Clyst Honiton Neighbourhood Plan Examination
Responses to Examiner’s Clarification by East Devon District Council

Extract 'Plan 2' from the s106 Agreement

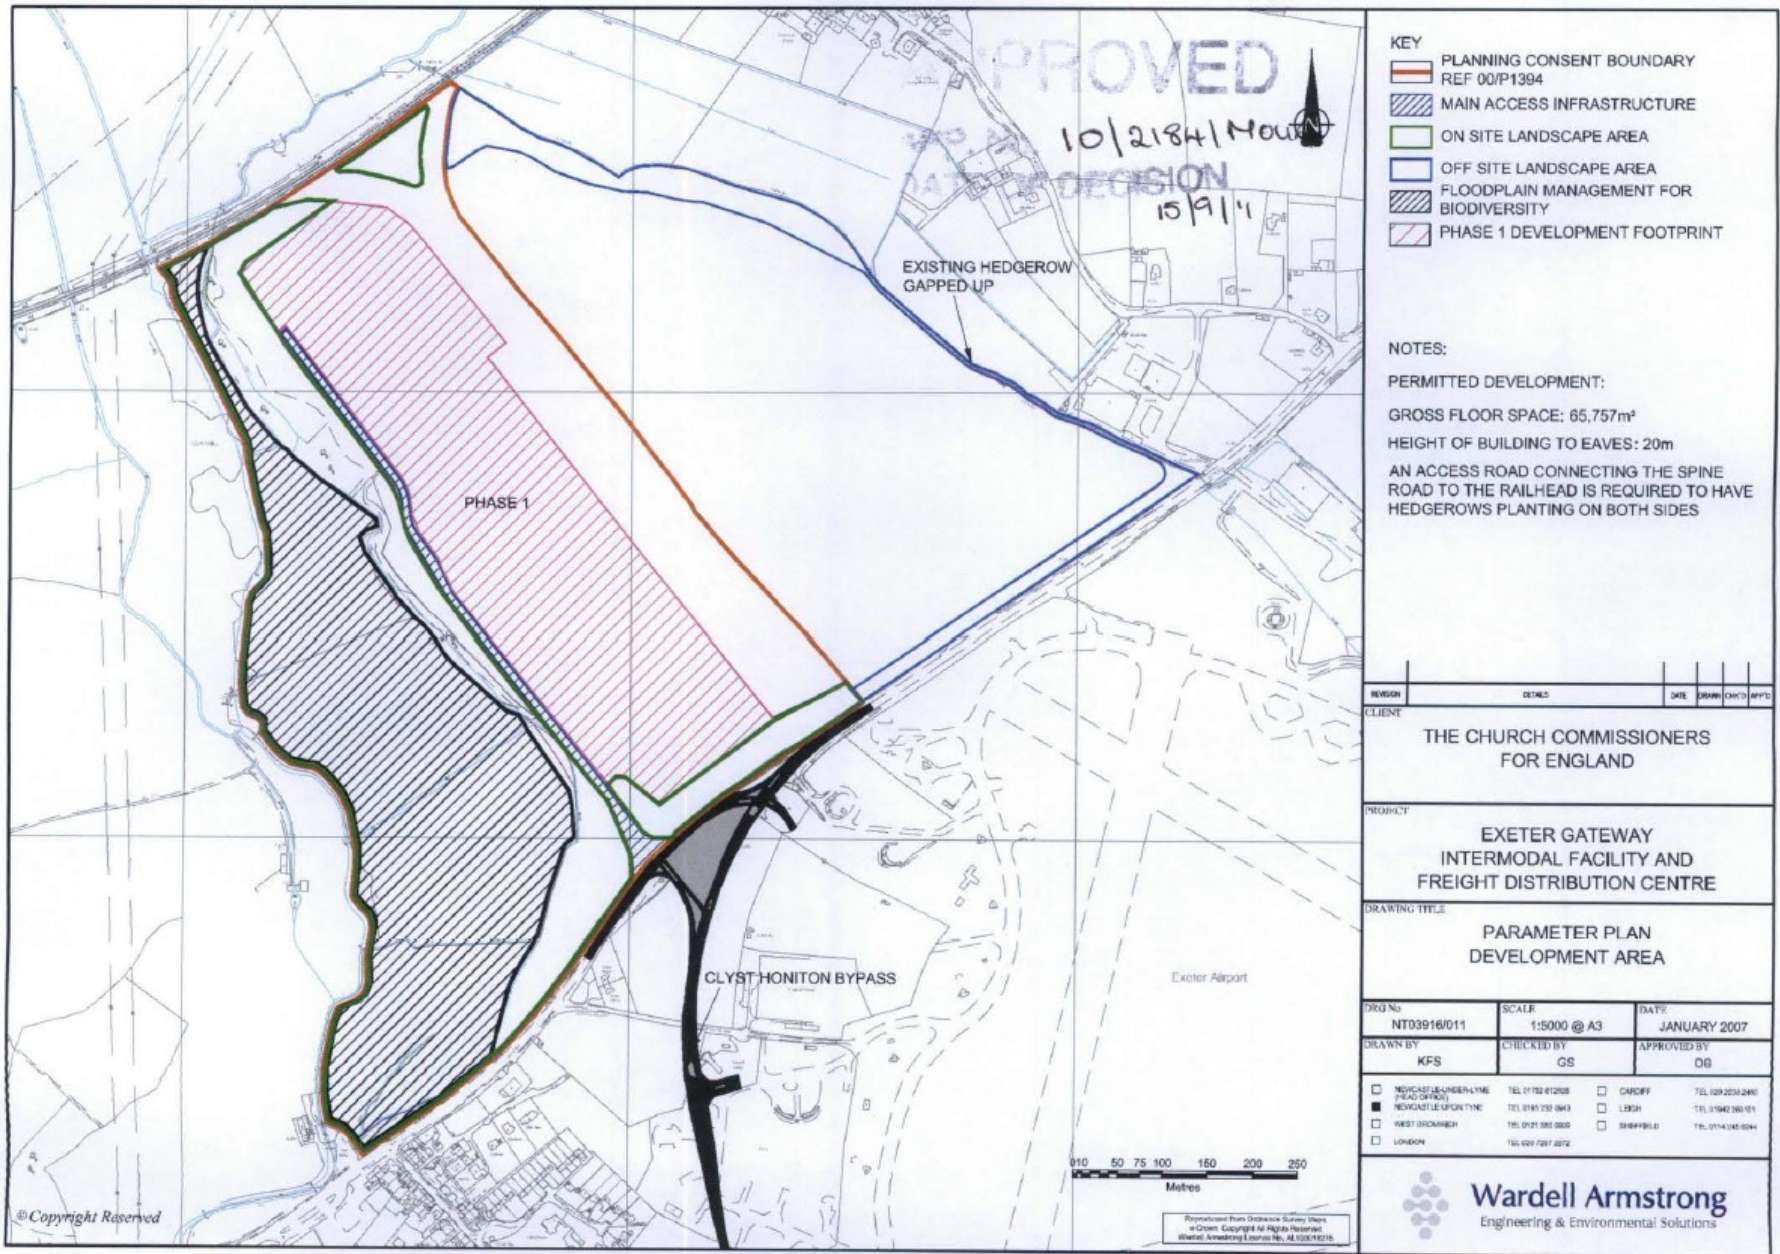
- a) Please could any update be given as to the current position with this site? Do EDDC remain supportive of this policy?
- b) I would welcome and invite comments from the Parish Council and EDDC on the representation from Lichfields on behalf of the landowner.
- c) There seem to be some missing words in the policy (last paragraph); please could the Parish Council advise?

EDDC can confirm that this land is subject to a section 106 agreement relating to the consent for the adjacent Logistics Park (17/0532/MOUT) for the provision of public access routes. Pursuant to this, EDDC served notice in 2020 to formally start the process for designation of the Public Rights of Way. We can confirm we are actively involved in discussions with CCE currently about getting the PRoW in place, but this is not finalised at present. We can also confirm that the access requirements set out in the s106 are restricted to the provision of a public right of way in perpetuity over land shown by the dashed yellow lines highlighted on Plan 2 in the s106 (shown below), together with a 5m wide access for private use by the owners to the non-public area to the north of the site (shown by the red line). It can be seen that this relates to a wider area of land, of which the land subject to policy NE3 forms part.
